NFPA Technical Committee on Water Mist Fire Suppression Systems (WAM-AAA)

NFPA 750 PRE-FIRST DRAFT MEETING AGENDA

September -22, 2020

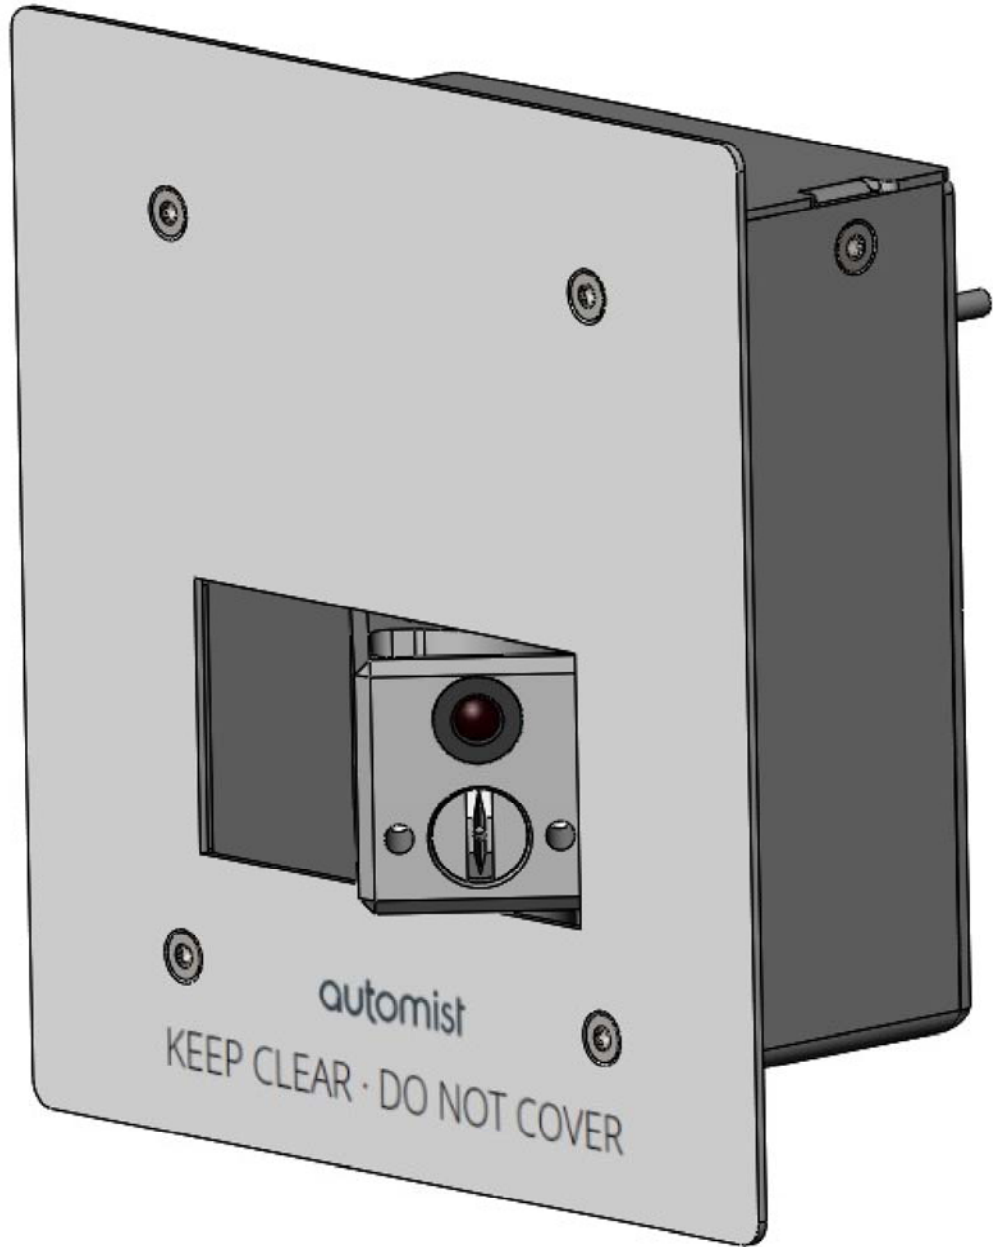
3.3.25.3 Directional Nozzle

A water mist nozzle which targets mist to the location of the fire once it has determined its location. These are typically open nozzles and are triggered by a detection system but are not for local application or deluge systems, instead, they address a number of potential risks within the nozzle's range.

We manufacture a domestic water mist system that uses a directional nozzle. Whether this is an open nozzle with a directional spray assembly is up to the technical committee to agree. Either way, it is not an automatic nozzle and it is not an open nozzle for a fixed local application nor for a deluge system. It is effectively a zoned single nozzle activation system which directs the mist in direction of the fire.

The current list of nozzle and system definitions does not cater for our water mist implementation so this is an attempt to either slightly adjust existing definitions or to create new definitions so that it does.

DRAWING N° SH14_AA

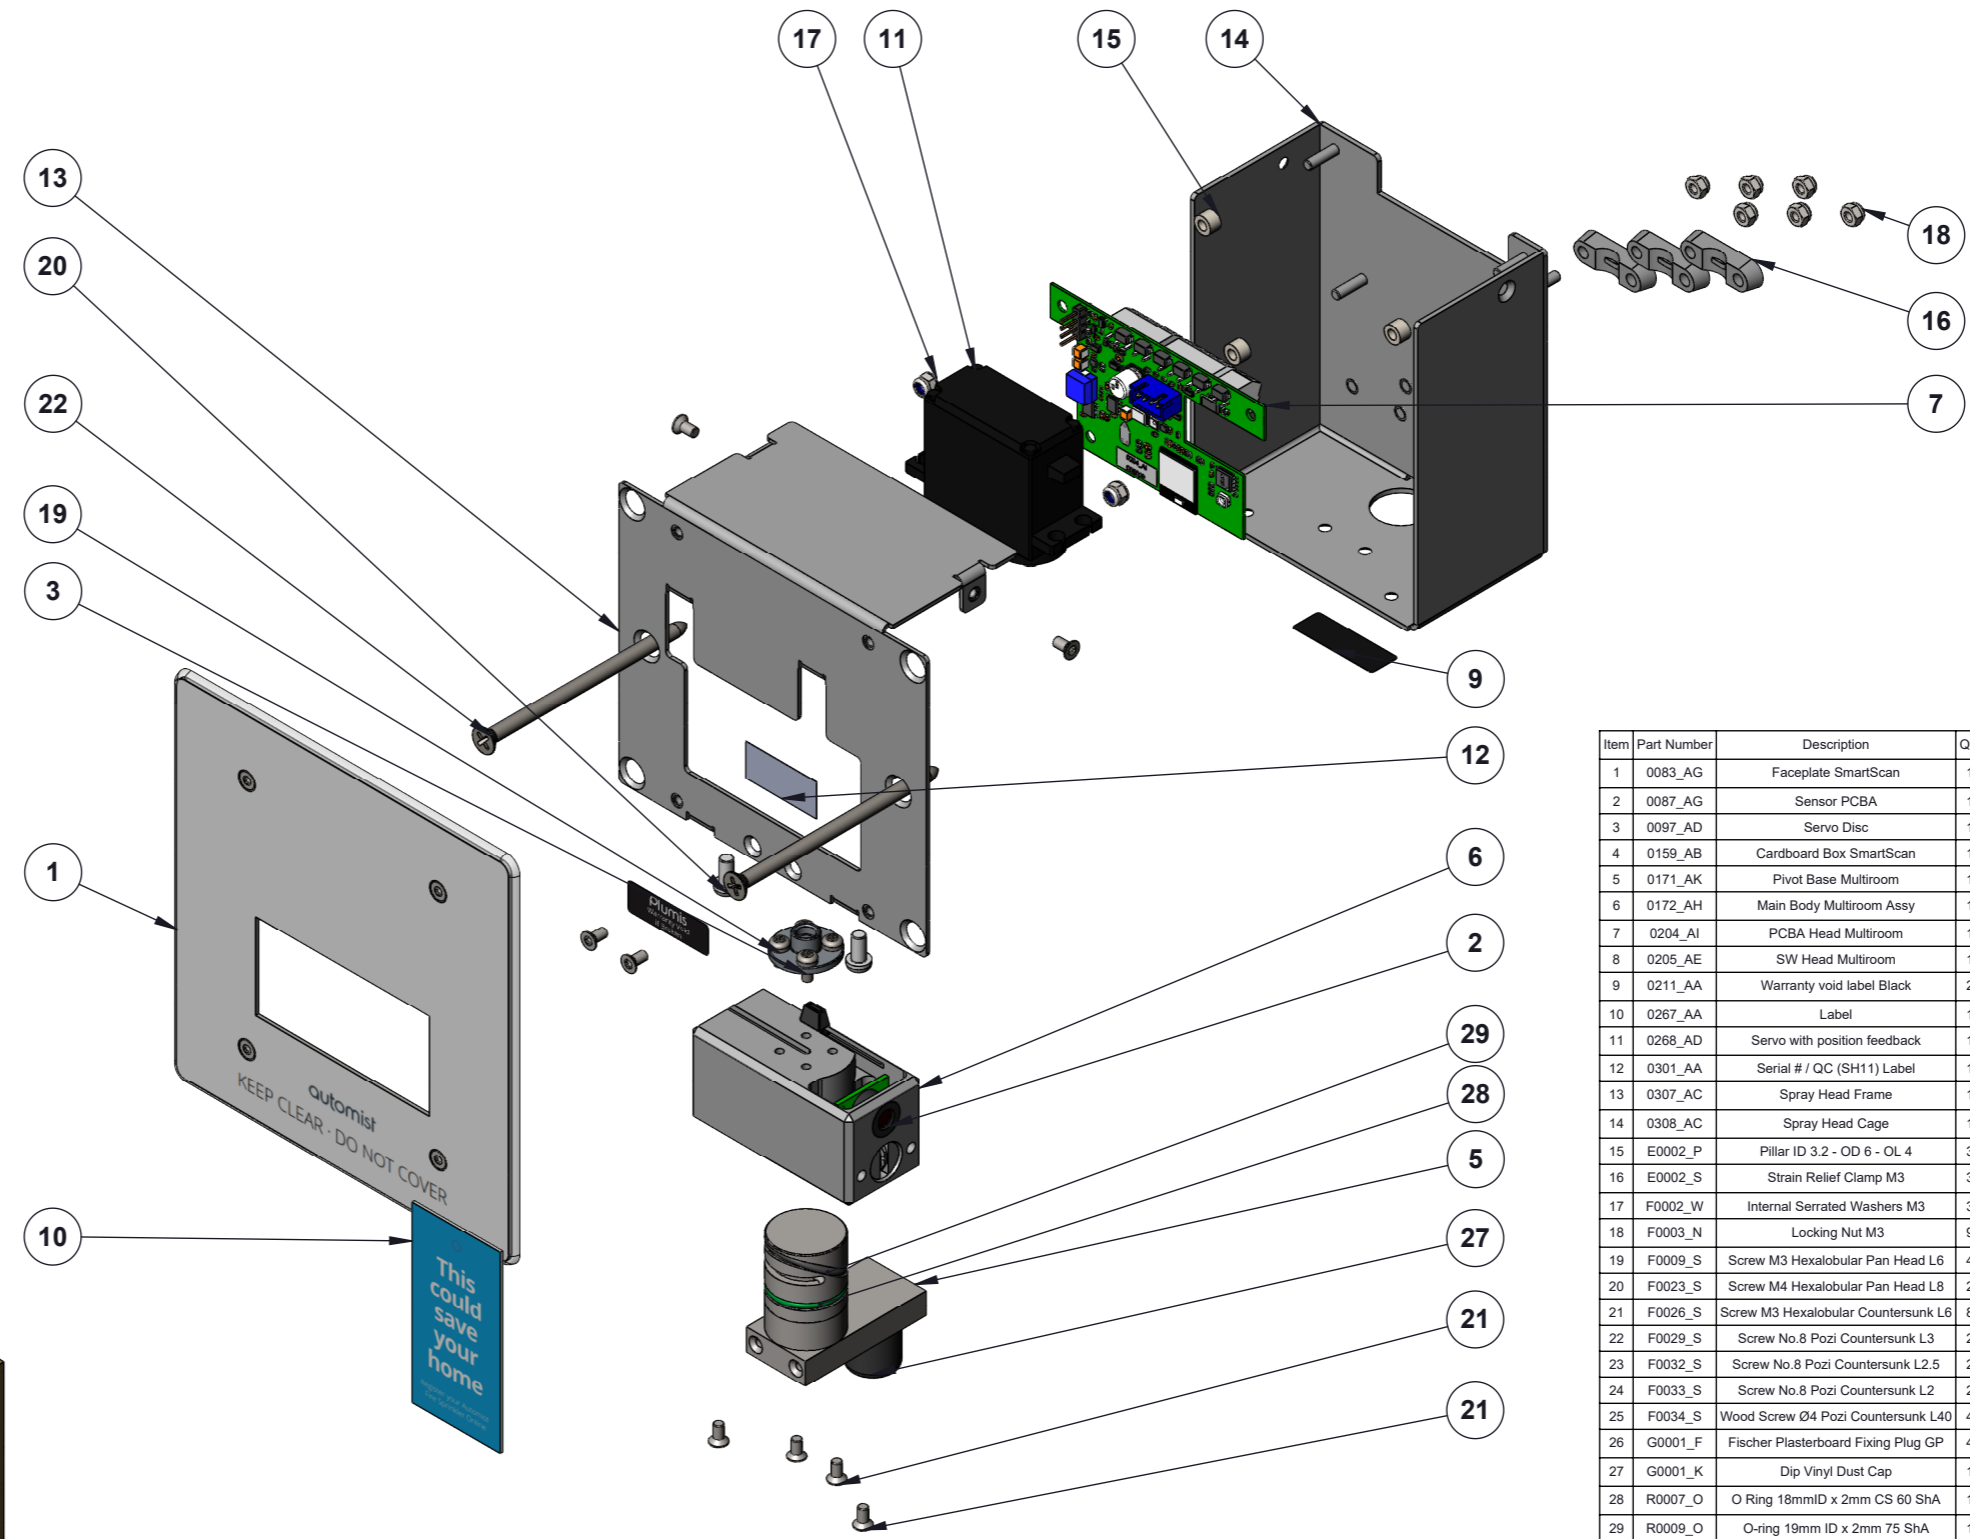
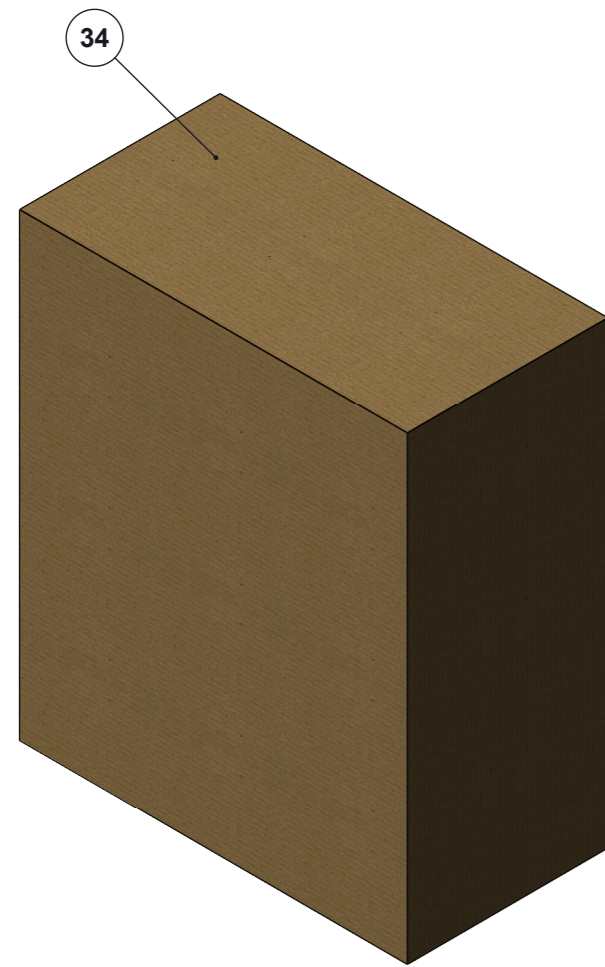
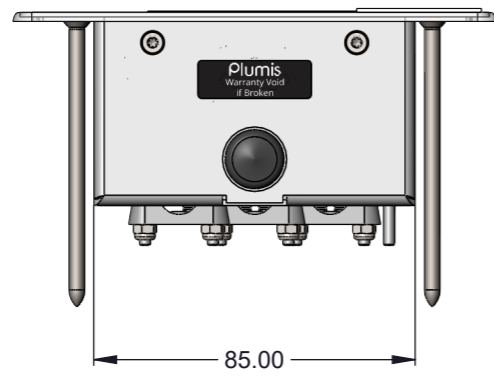
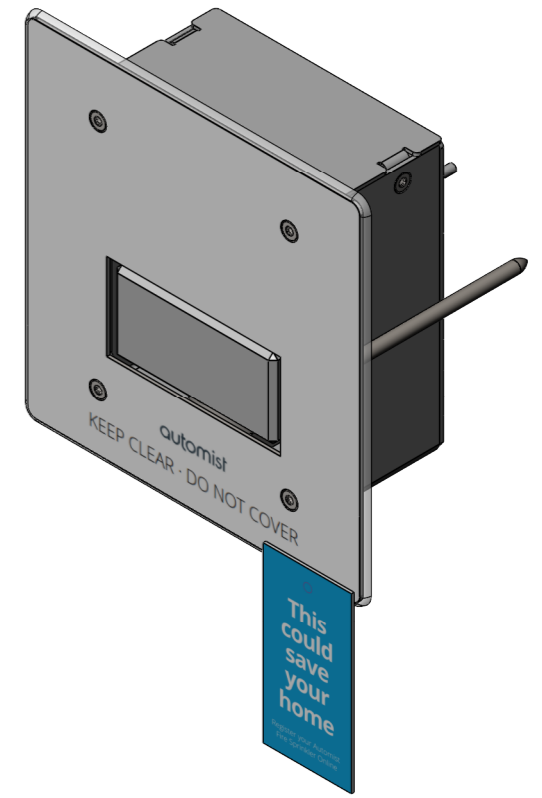
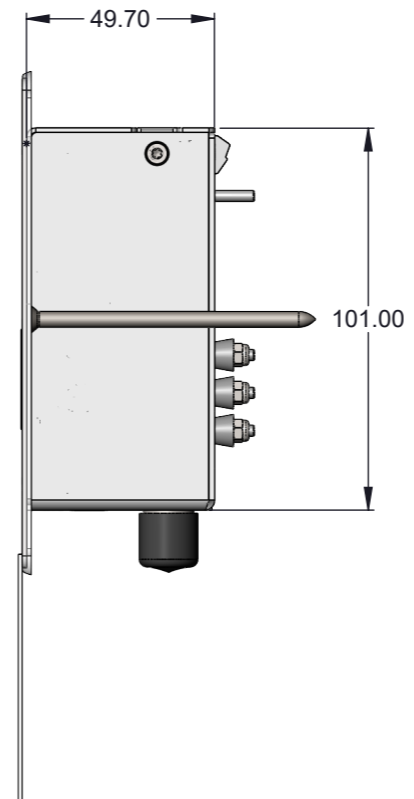
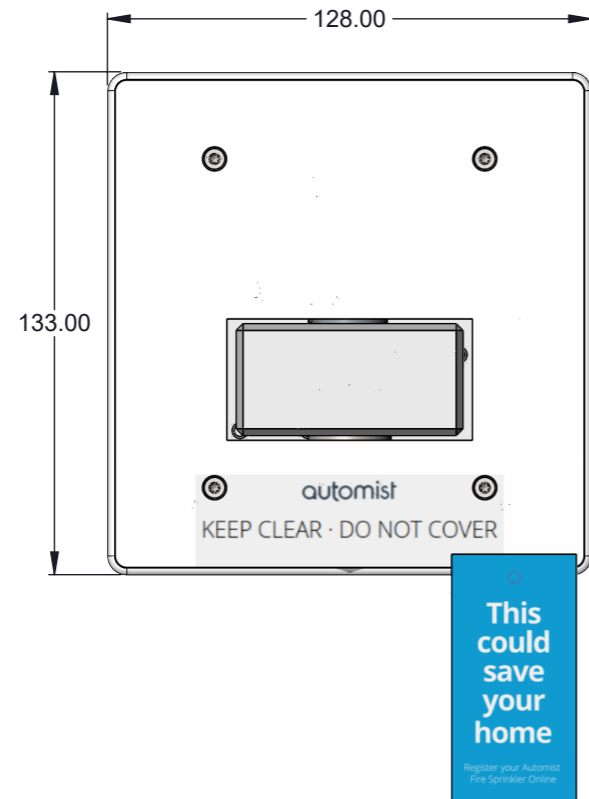
| <u>File Name</u> | <u>Description</u> | <u>Approved</u> |
|---|---|-----------------|
| SH14_AA_Multiroom_Spray_Head_Rev.01.PDF | Exploded image of spray head for illustration of directional nozzle | |
